CULVER'S JSP 23-37

PLAN REVIEW CENTER REPORT

Planning Review

Revised Preliminary Site Plan with Planned Development 2 Option, Special Land Use Request, and a Street Vacation Request

02 of 22

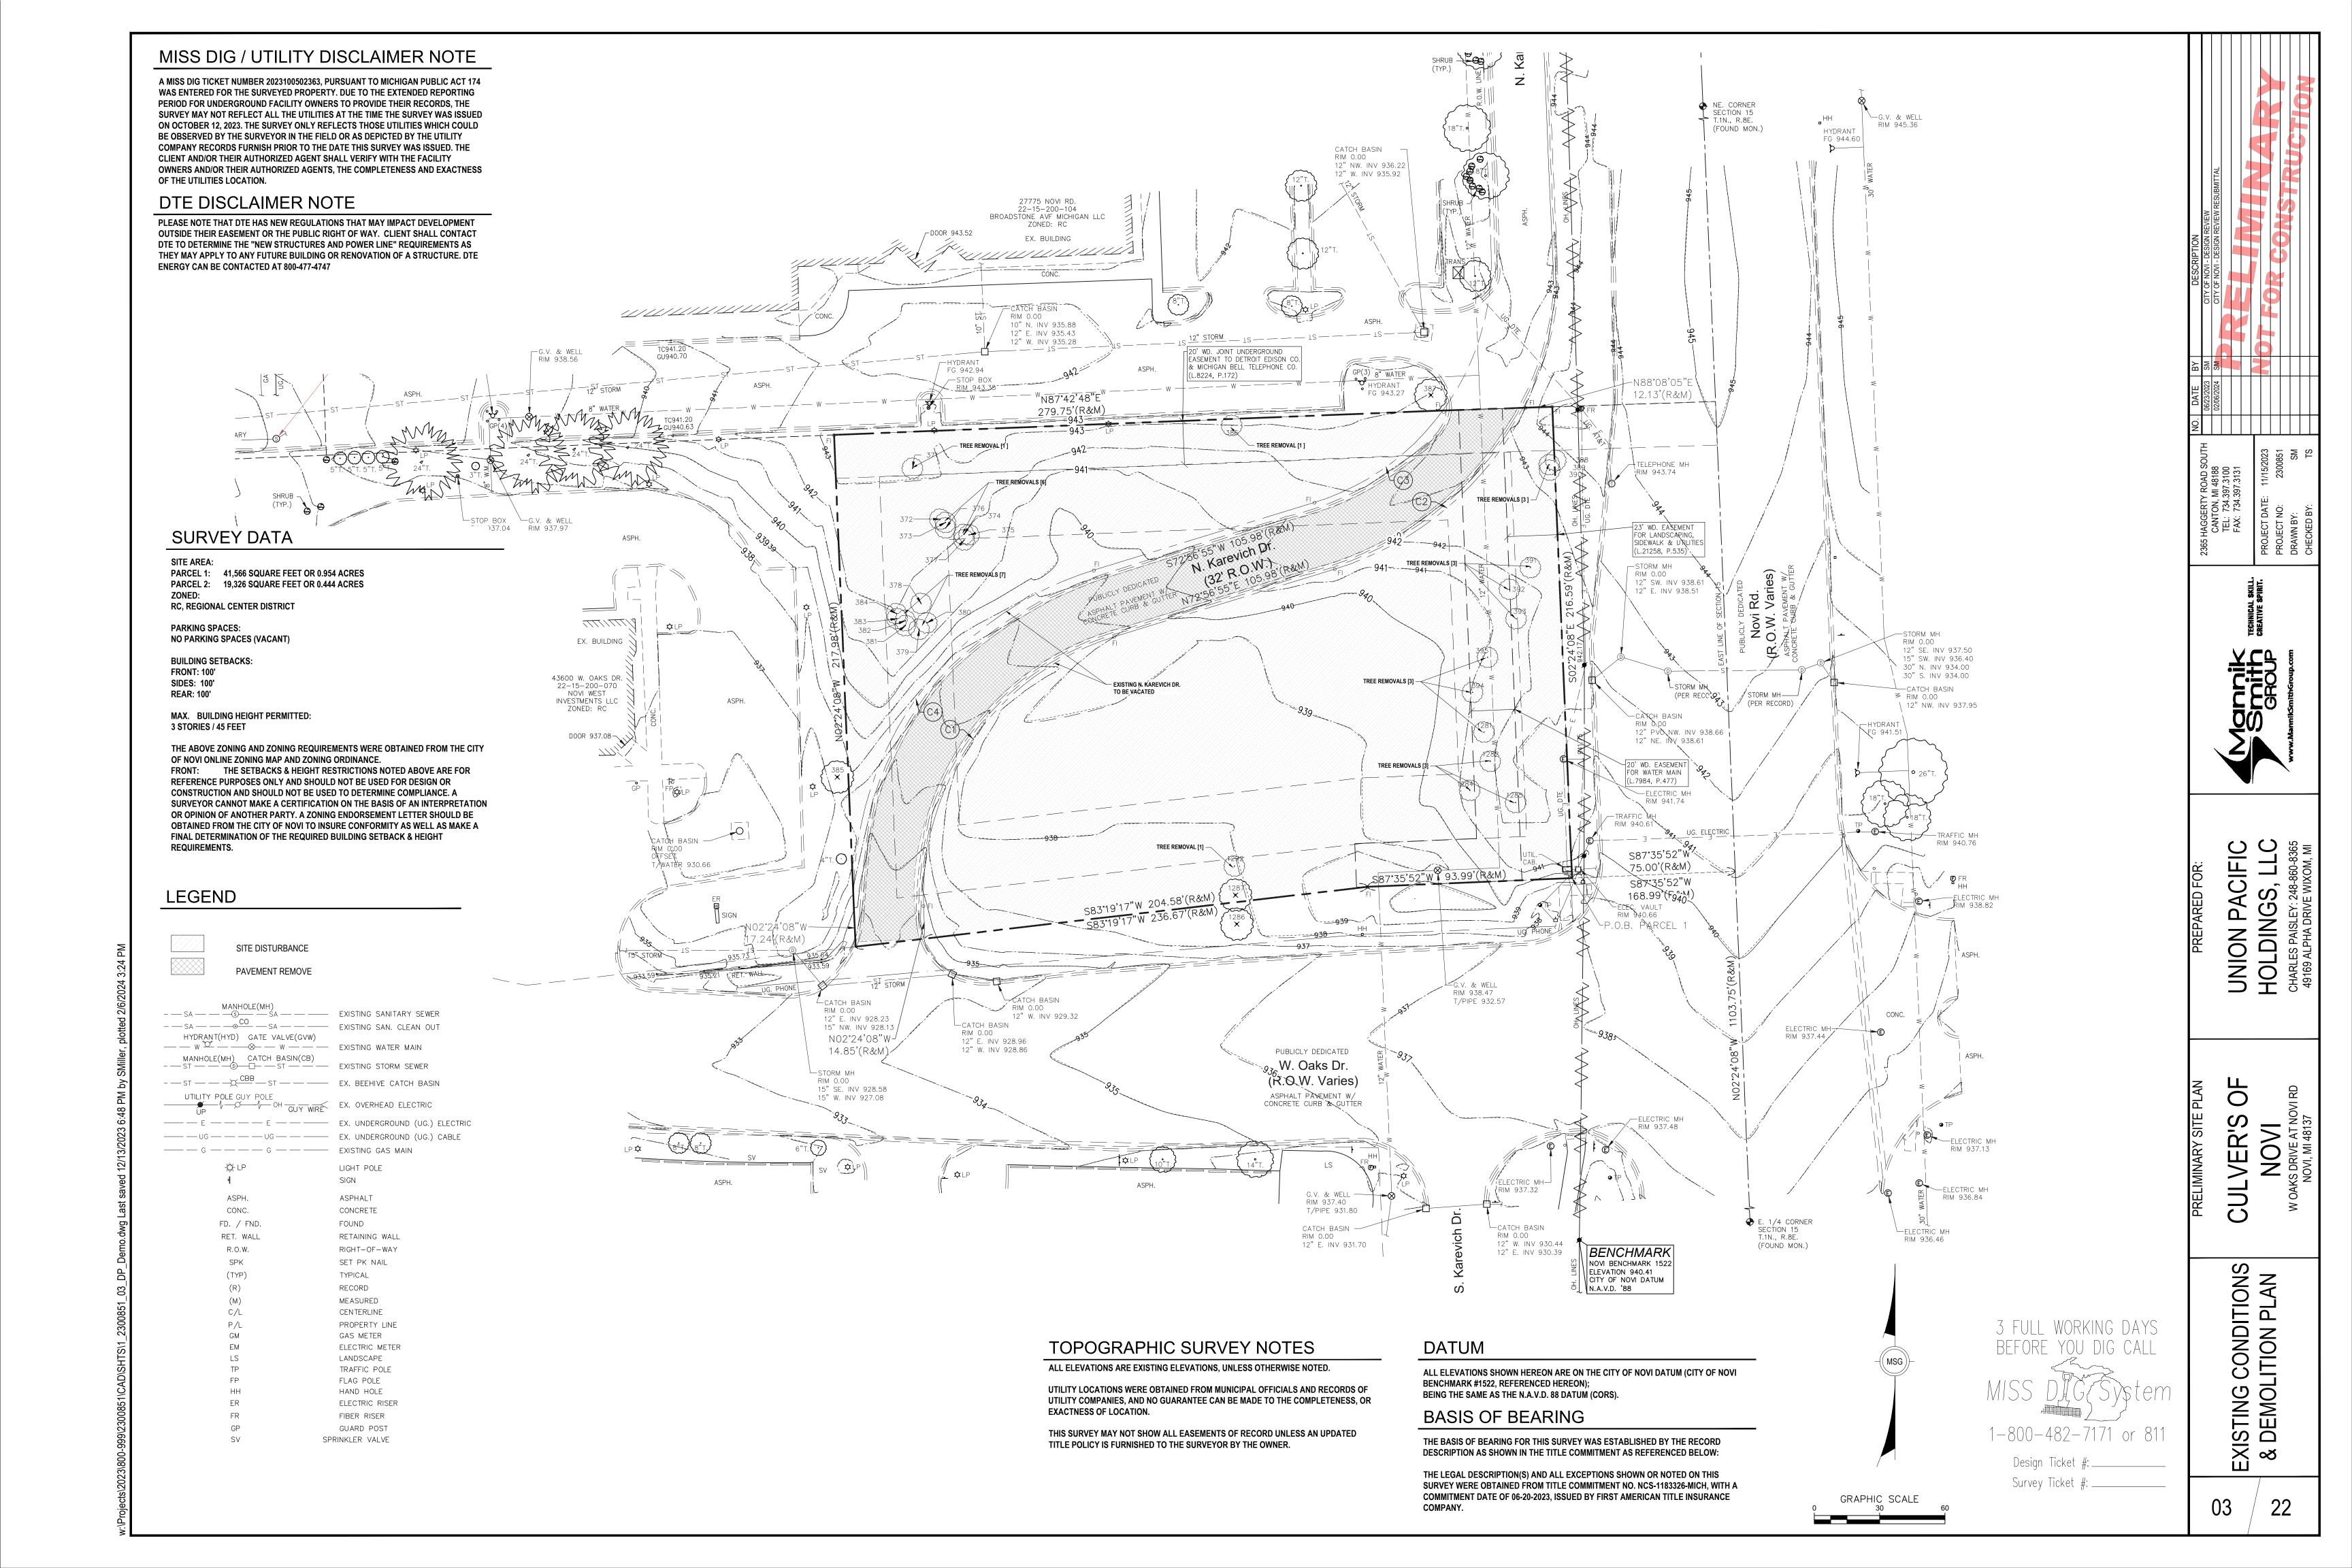
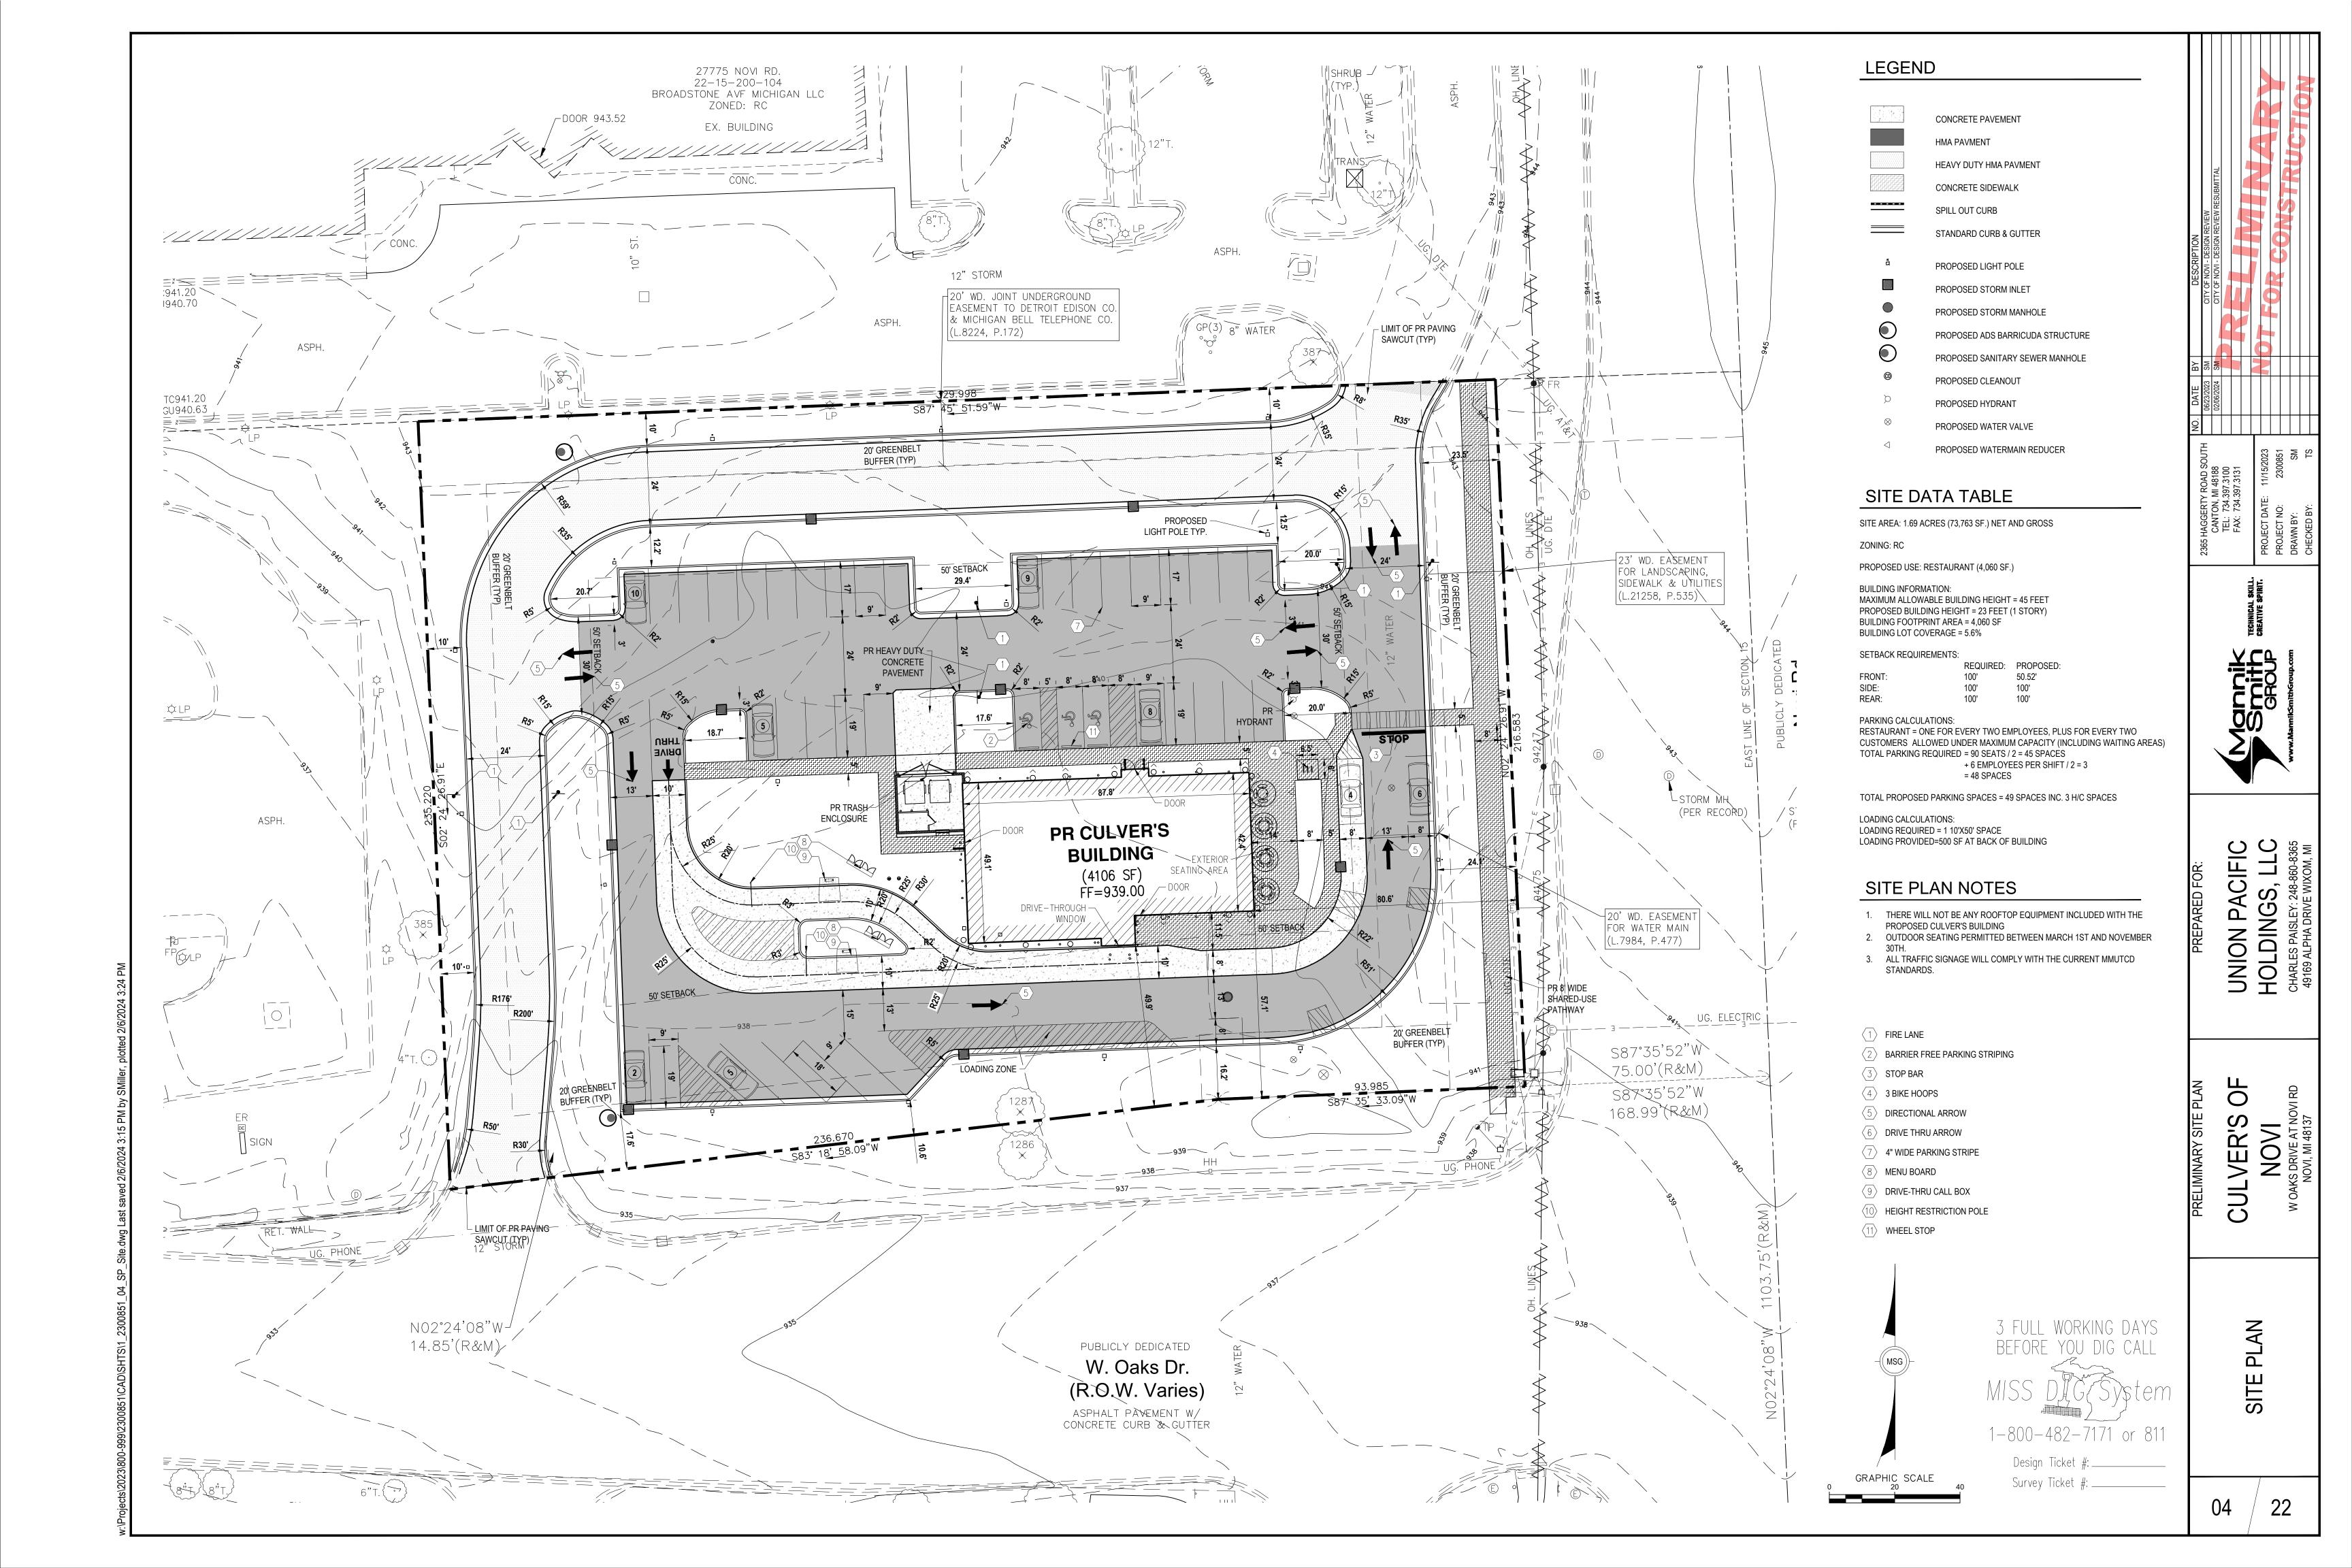
- 3. <u>Drive-thru Stacking Spaces (Sec. 5.3.11.1):</u> The distance between the order board and the pick-up window shall store four vehicles, and four vehicles shall be stored in advance of the menu board Please dimension the stacking spaces to show that 19 feet is provided per stacking space. See Traffic Review letter for further details.

- 4. <u>Drive-thru Bypass Lane (Sec. 5.3.11.D)</u>: Drive-through facilities shall provide one bypass lane to allow unobstructed travel for vehicles to pass those waiting to be served. Such bypass lane shall be a minimum of 18 feet in width, unless otherwise determined by the Fire Marshal. **The current bypass lane is 13 feet in width. This will need to be adjusted to comply with the Ordinance. The Fire Marshal is requesting that the bypass lane be 20 feet in width.**
